Re: Initial Submission Review – Revolve Denali at Windler – Site Plan
Application Number: **DA-1707-25**
Case Numbers: **2023-4003-00**

Initial Submission Review

DEN Aviation Noise:

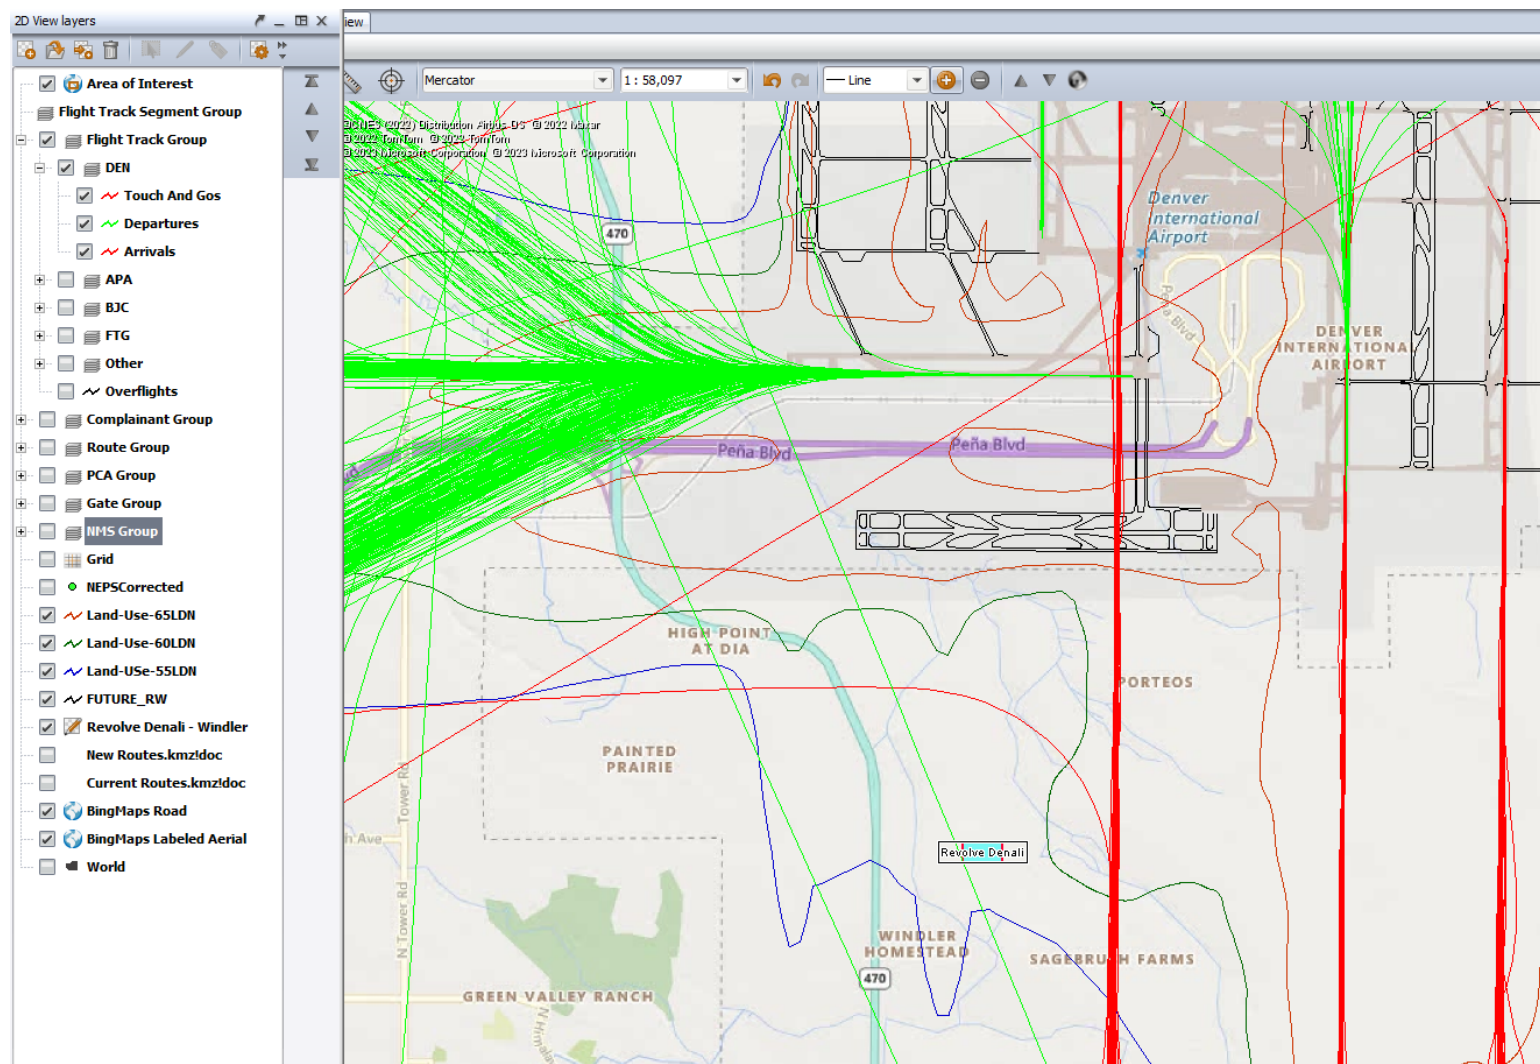
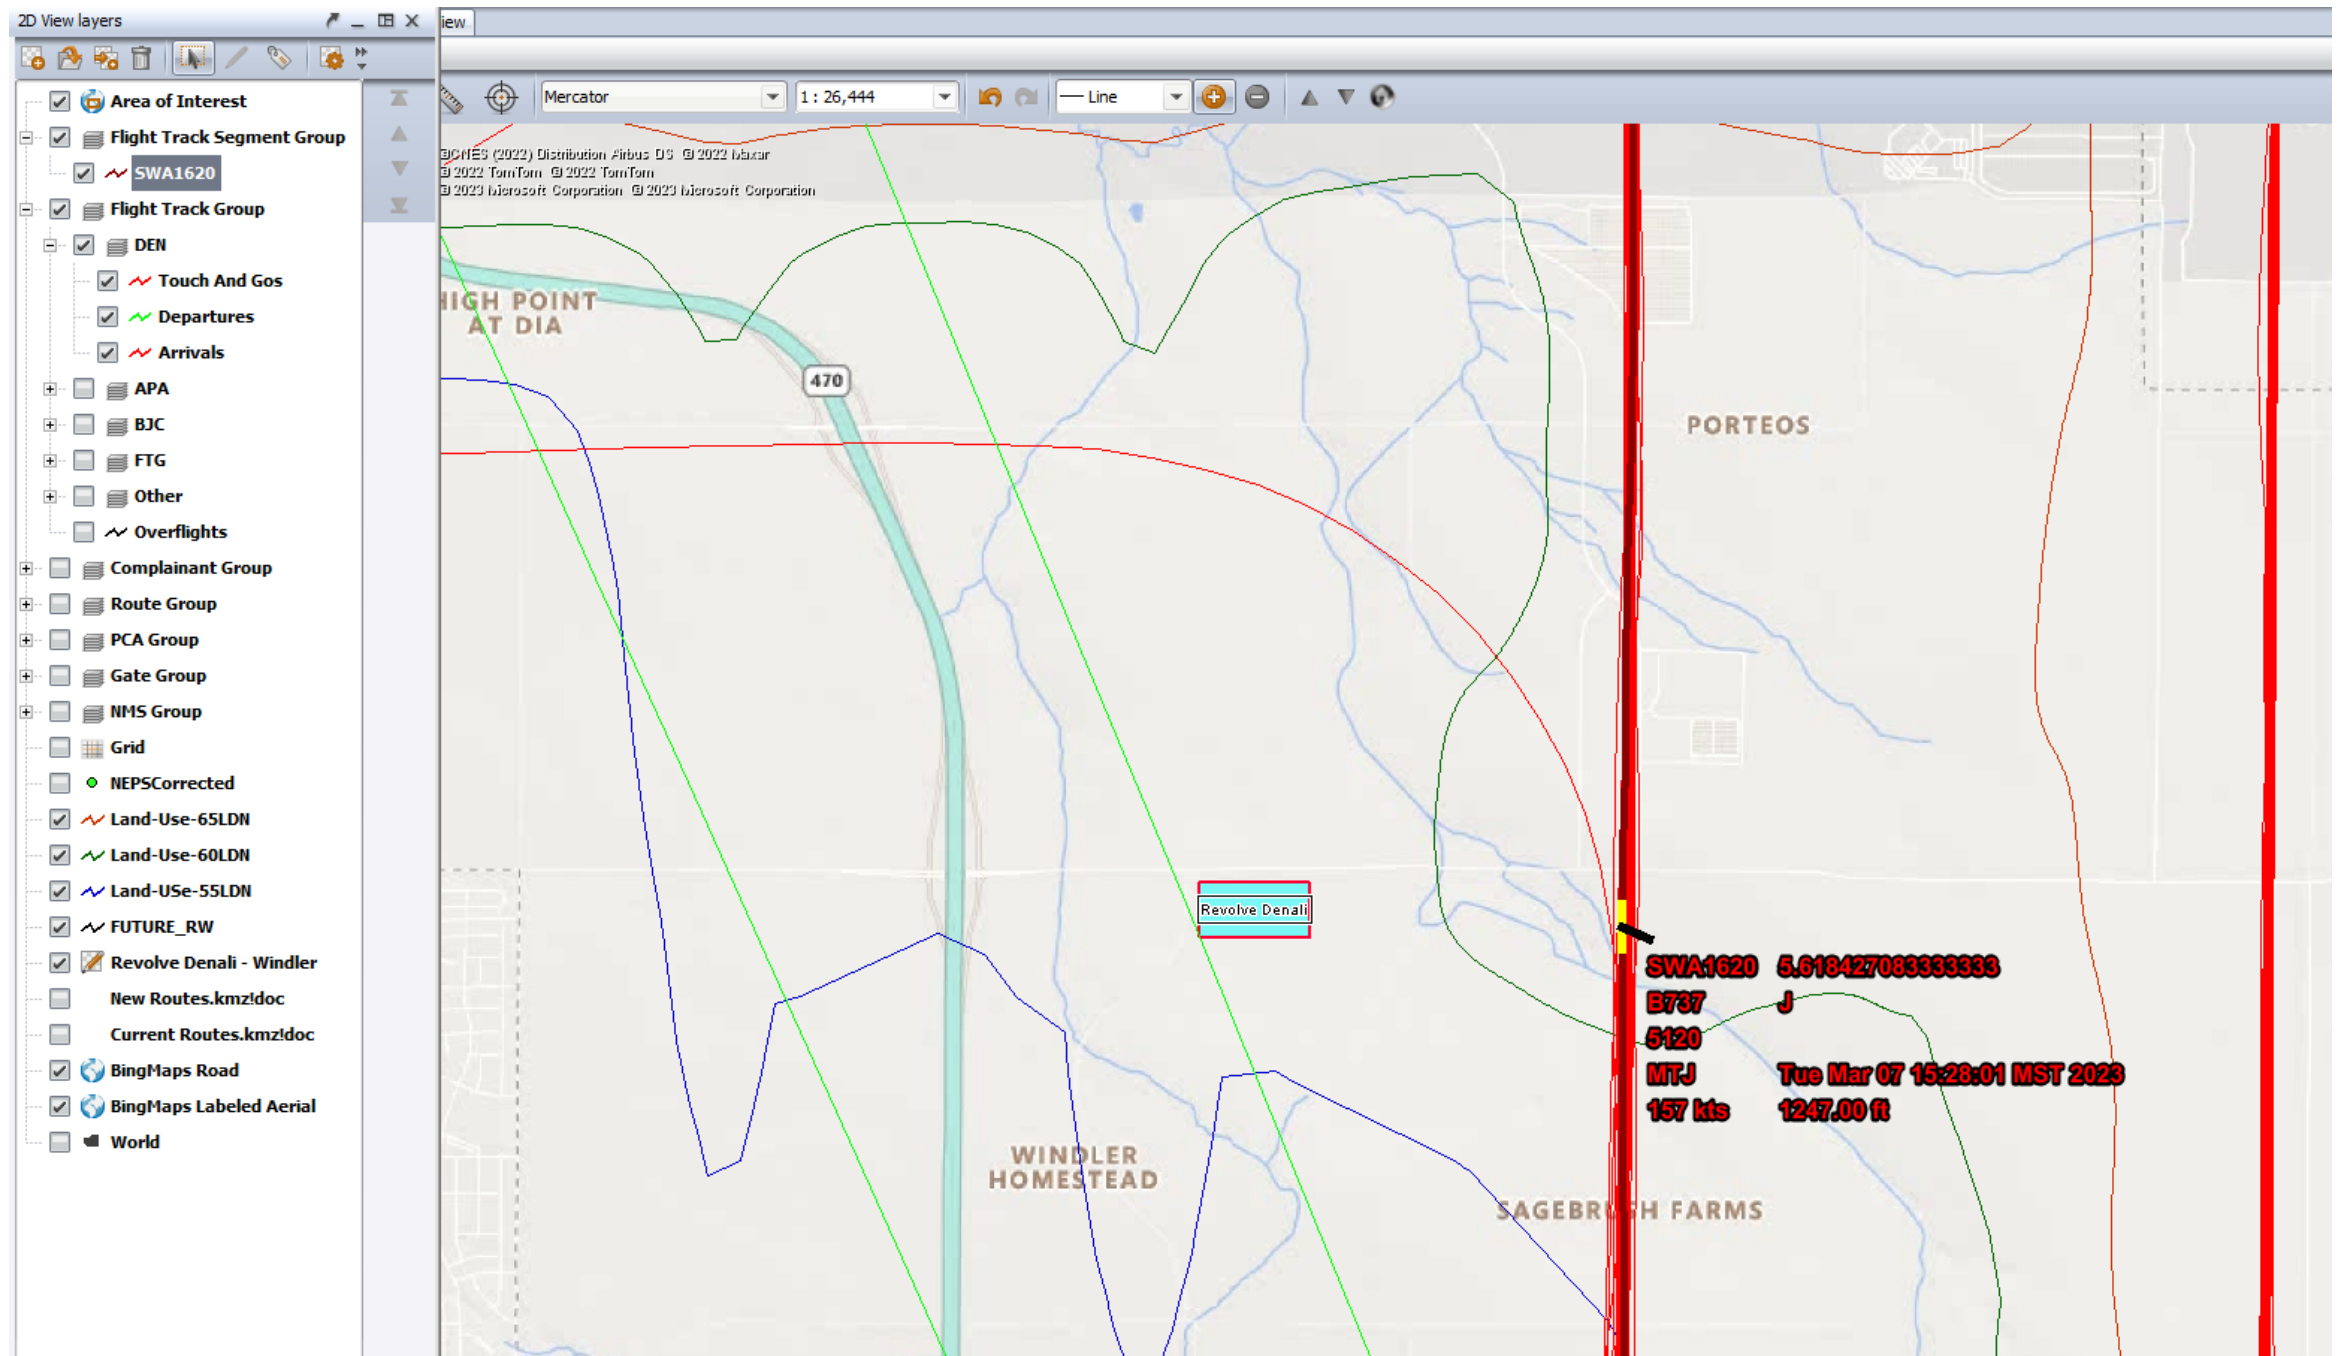
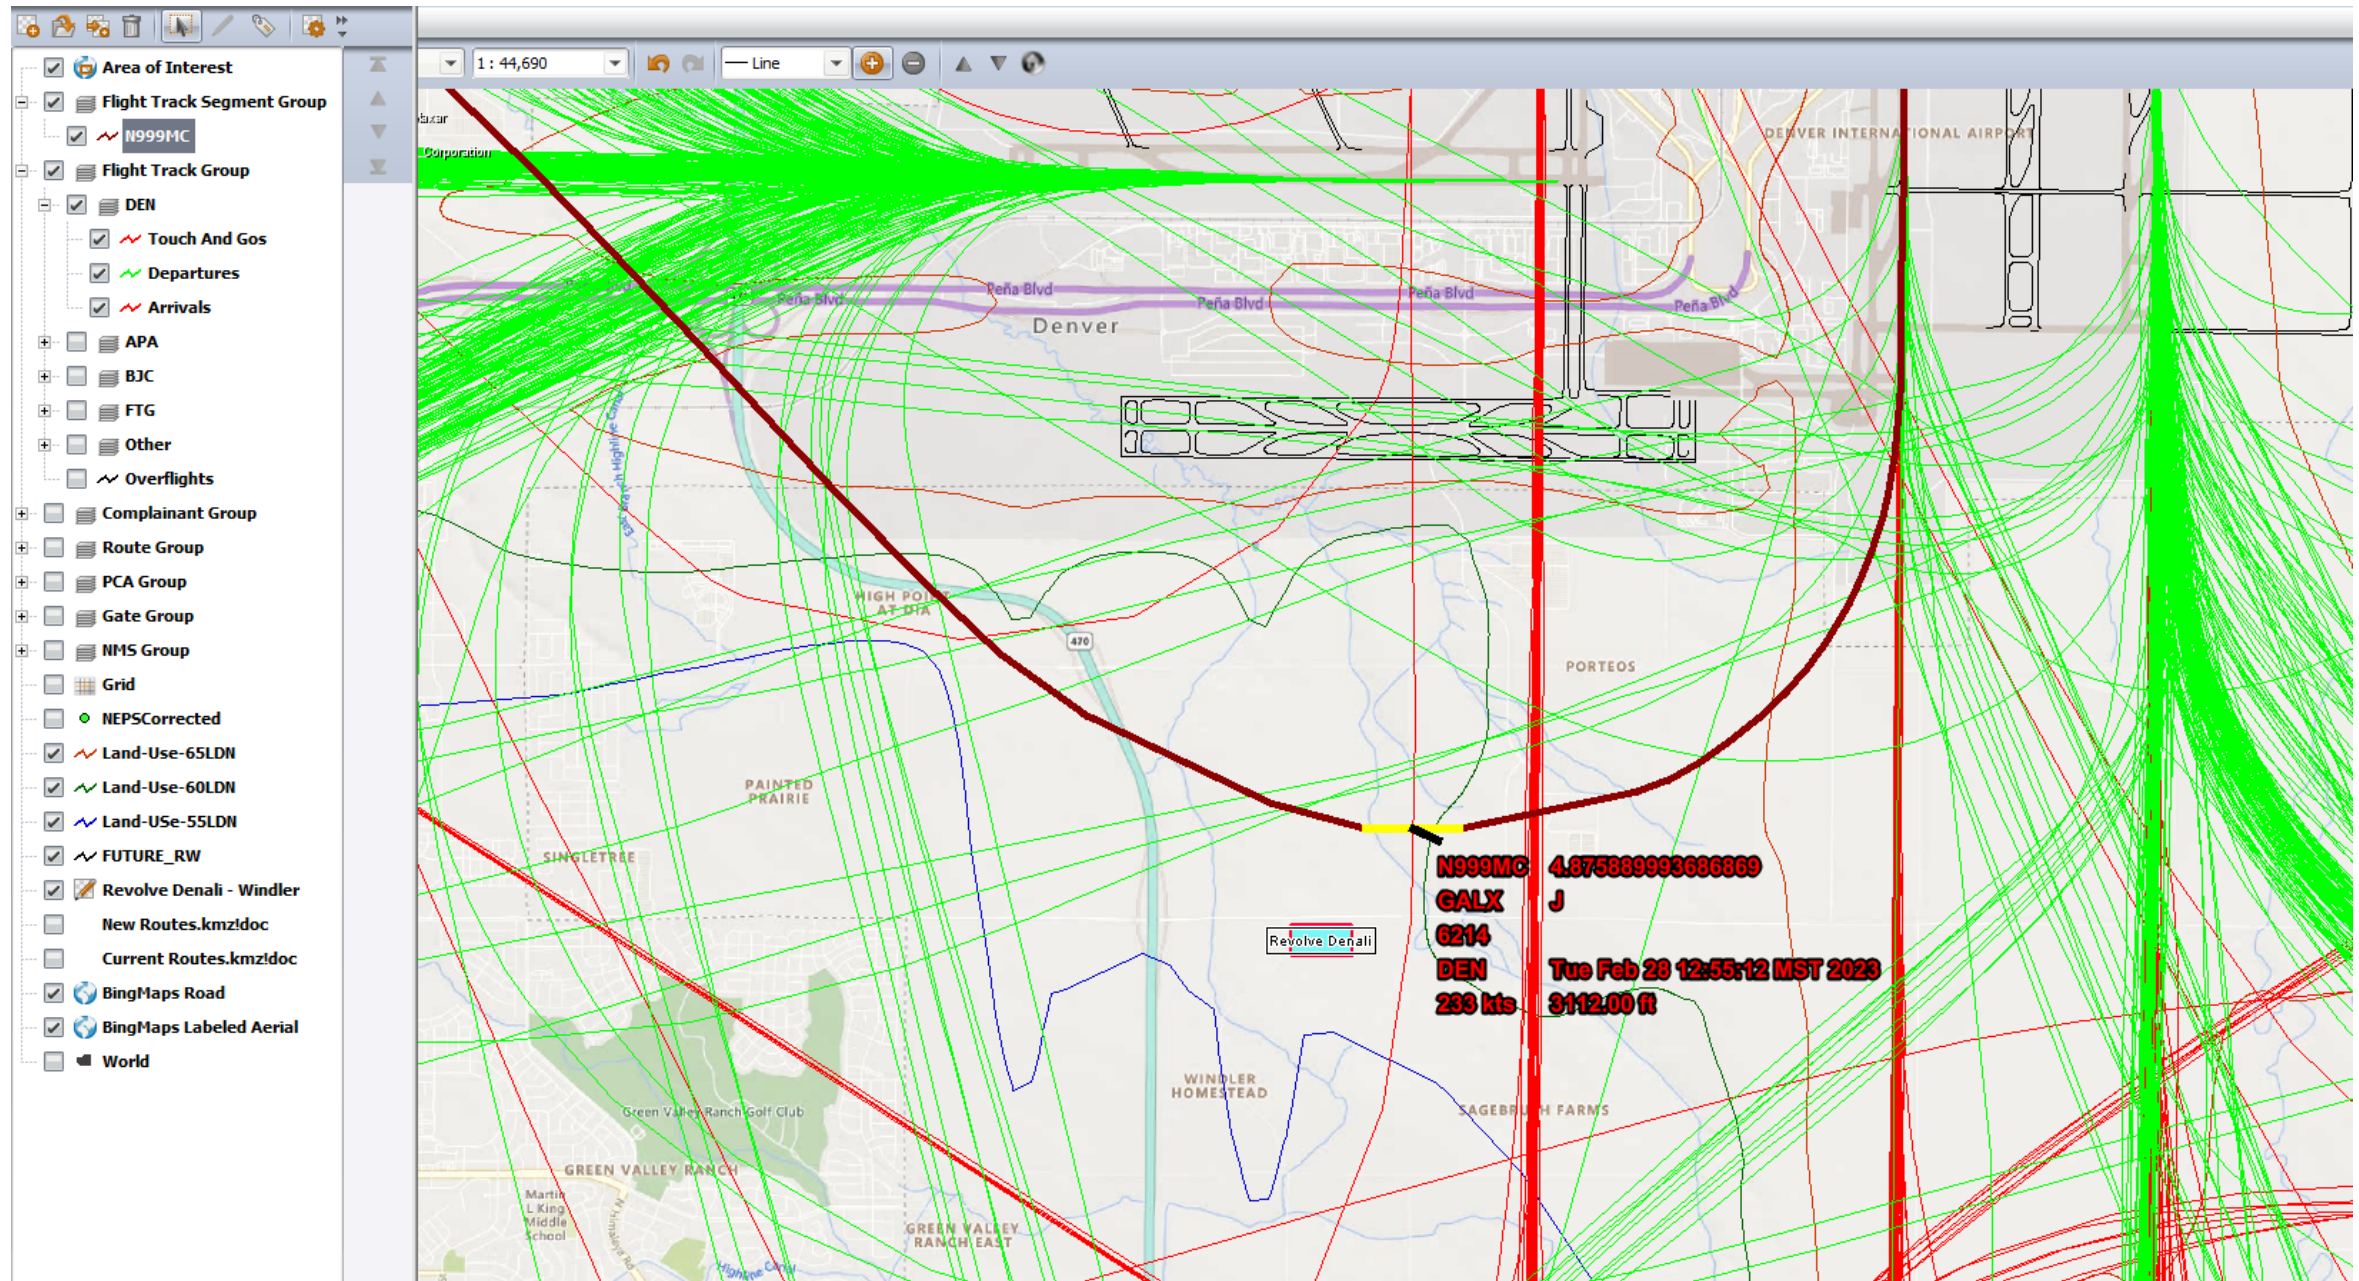
This subject property area is not currently under and arrival pattern, the future north/south runways on the west side of the airfield will put arrivals over the subject property. This portion of the development could potentially have arrival overflights from the south at altitudes of between 1,100 feet above ground level (AGL) and 1,500 feet AGL depending on the aircraft type and what arrival runway the Federal Aviation Administration (FAA) air traffic controllers have directed the aircraft to land on. If the winds are out of the north aircraft will land coming in from the south on final approach to DEN. Aircraft currently arrive to DEN on runways 34L and 34R and with the potential of 4 North/South runways on the West side of the airfield there could be even more daily arrival overflights of this development. The future runways are depicted in black on this map of flight data from 3/7/23. This days of flights depicts a typical flight pattern for a 24 period. See next page for a zoomed in version.

Same flight data from 3/7/23, zoomed in to see the 55, 60 and 65 DNL contour and the property area in light blue. This subject property lies within the 55 DNL. This portion of the 55 DNL contour shows the noise footprint of aircraft arriving/departing to/from the additional 2 potential north/south runways on the west side of the airfield. Once the runway straight north-northwest of this property is built, 16C/34C (might be the runway name) there will be overflights at the beforementioned altitudes. There could be upwards of 200+ arrivals per day to those current/future runways, at anywhere between 1,110 feet AGL to 1,500 feet AGL depending on the aircraft type.

Flight data from 2/28/23. Few arrivals vectoring to get in line for final approach to 34L or 34R and there are also some departures that could fly near the subject property. On this day there were a few departures from runway 17L and 17R as well as runway 25. Their altitudes can vary based on aircraft type. On this day they were between 2,600 feet AGL and 4,100 feet AGL. These aircraft will be louder than arrivals as they are under full power departing DEN. During periods of high winds, inclement weather or runway capacity issues the FAA will depart aircraft to the south from runways 17L/R and then turn them west to get back onto the final assigned pattern. This could happen from any one of the north south runways. For the same reasons noted above, the FAA will direct departures from runway 25 to depart west and then turn to the south to then get them onto their final assigned pattern. This departure was approximately .45 miles to the NE of the subject property.
